Addendum 2 Solicitation 22-99533 Lincoln Park Site Improvements

ADDENDUM NO. 02, JULY 27, 2022

RE: Lincoln Park Site Improvements

LHB Project No. 170032

LANDSCAPE PLAN **OVERALL VIEW**

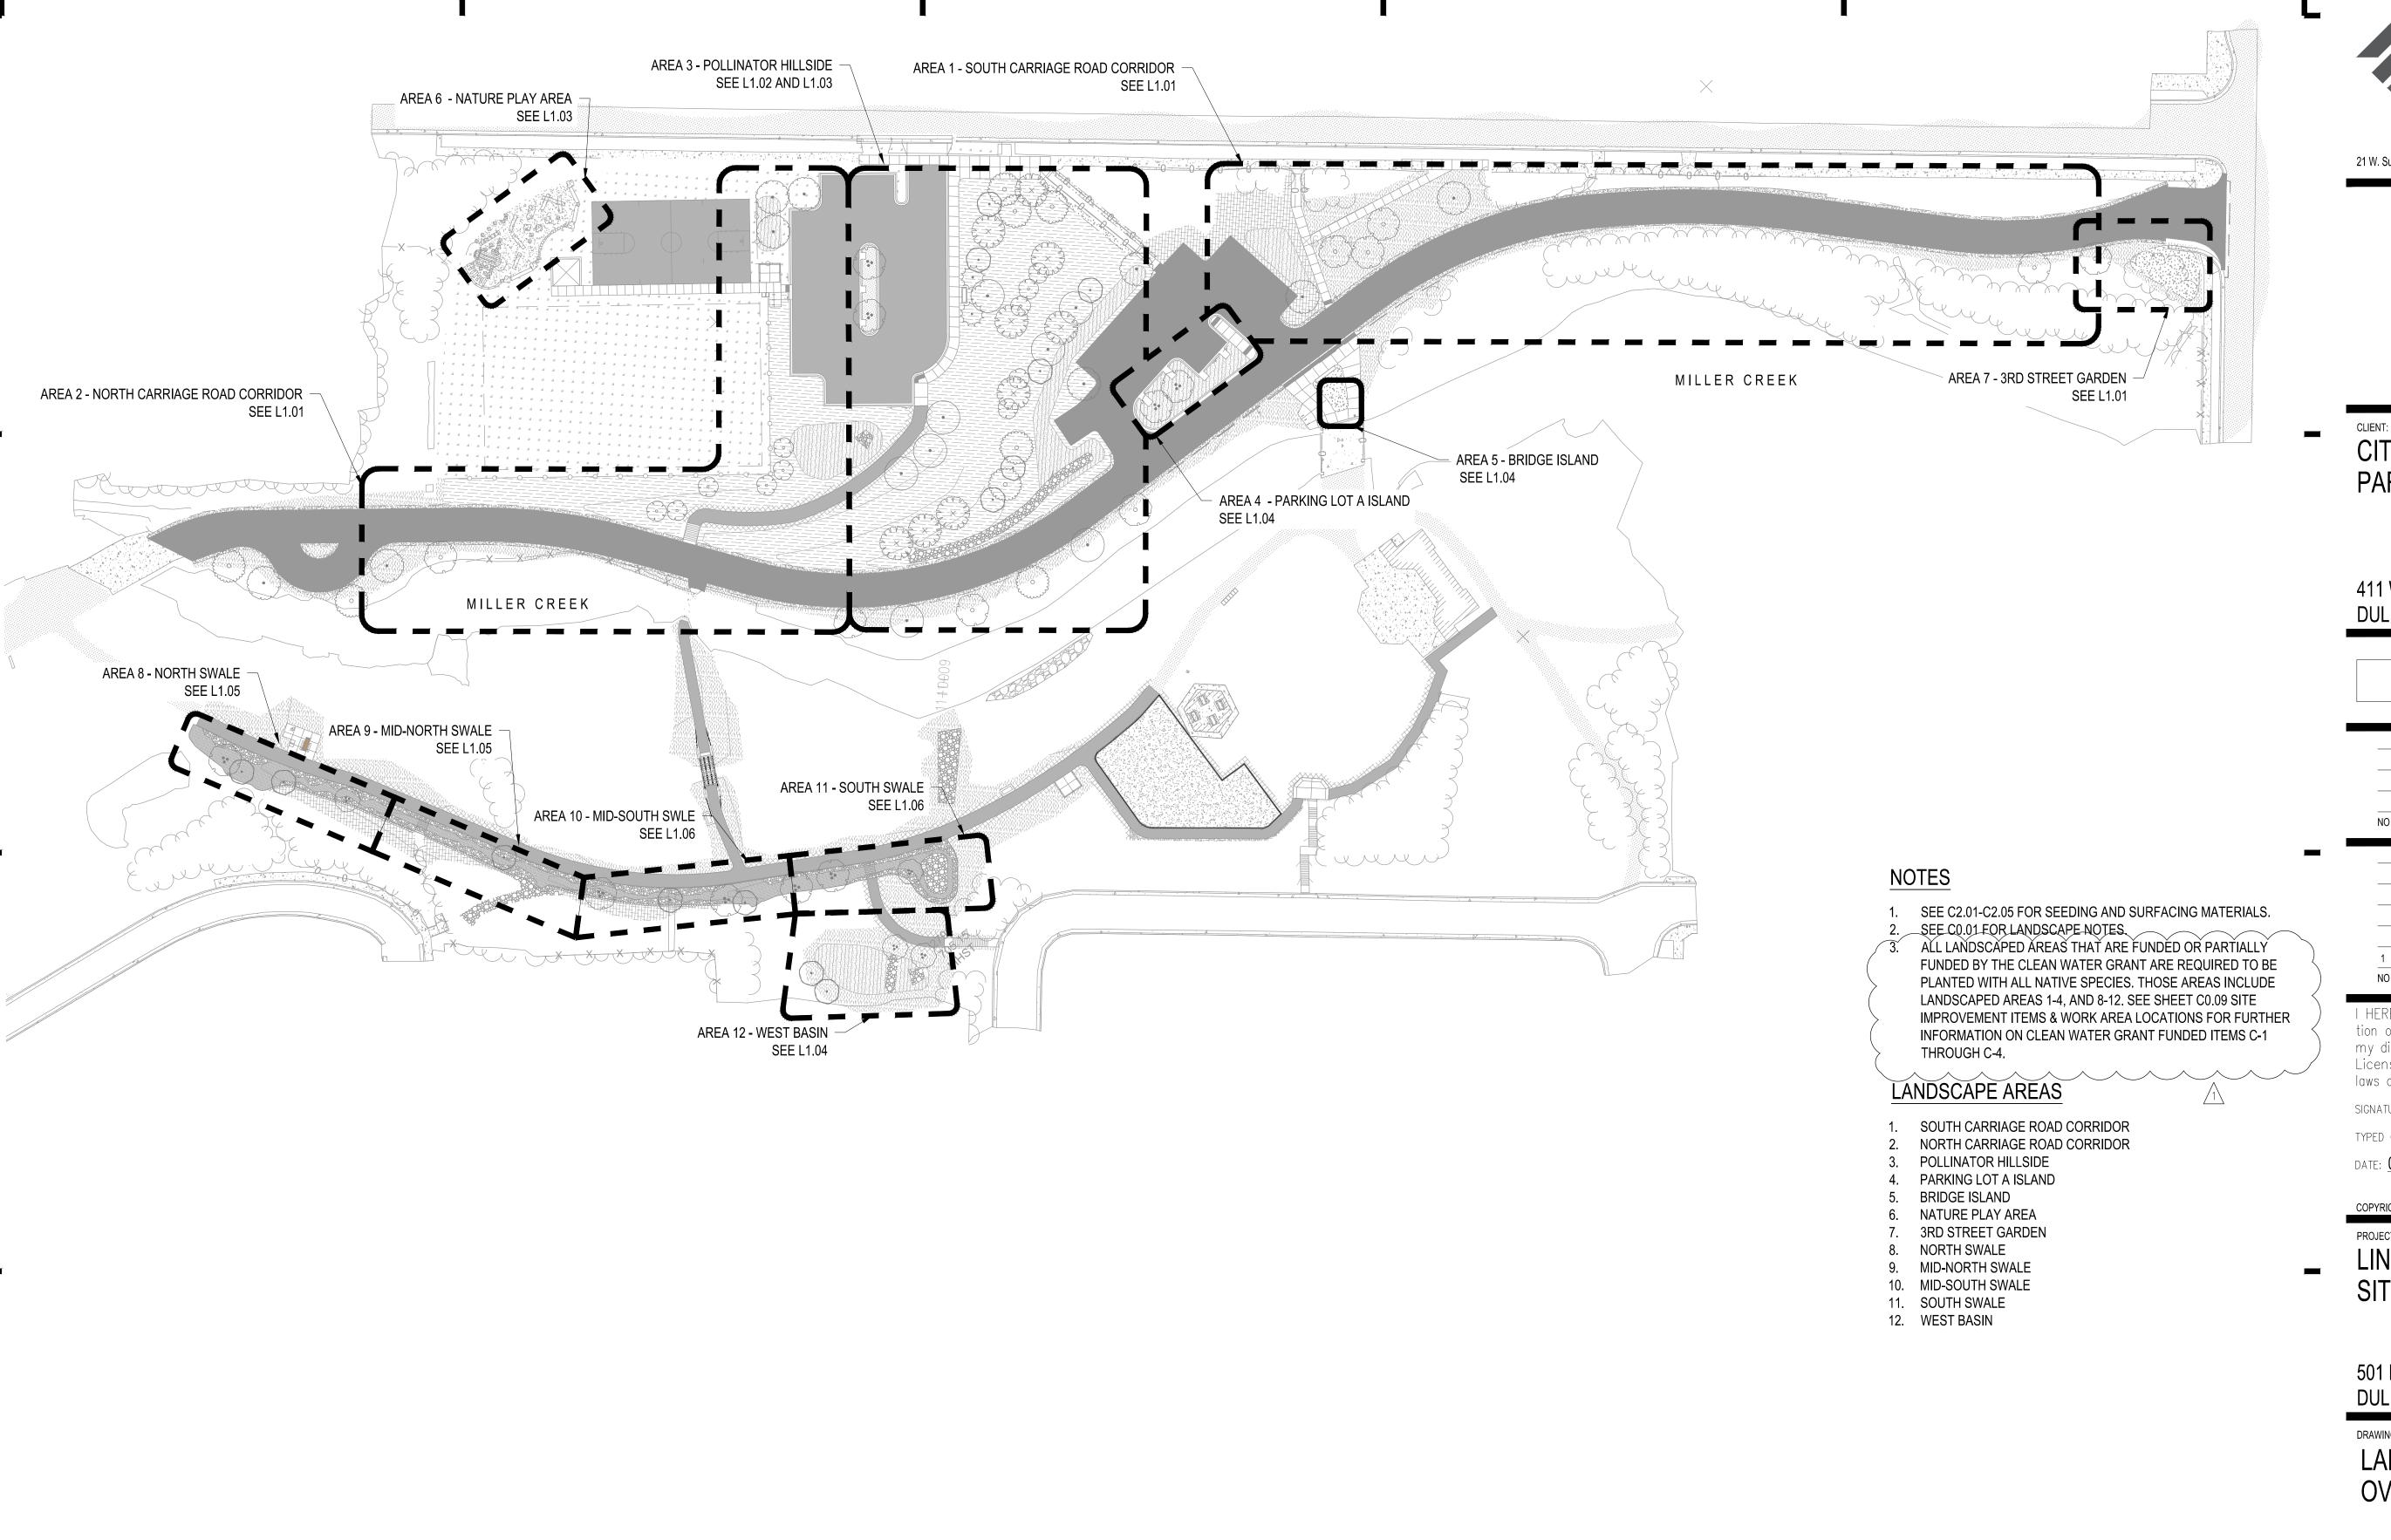
- 2. A copy of the Memorandum of Agreement (MOA) with all regulating consulting parties is attached for reference.
- The Clean Water Grant Site Improvement funded items require all plant material to be native species. These
 areas include C-1, C-2, C-3, and C-4 illustrated on C0.09. Sheet L1.00 has been modified to include this
 requirement note.
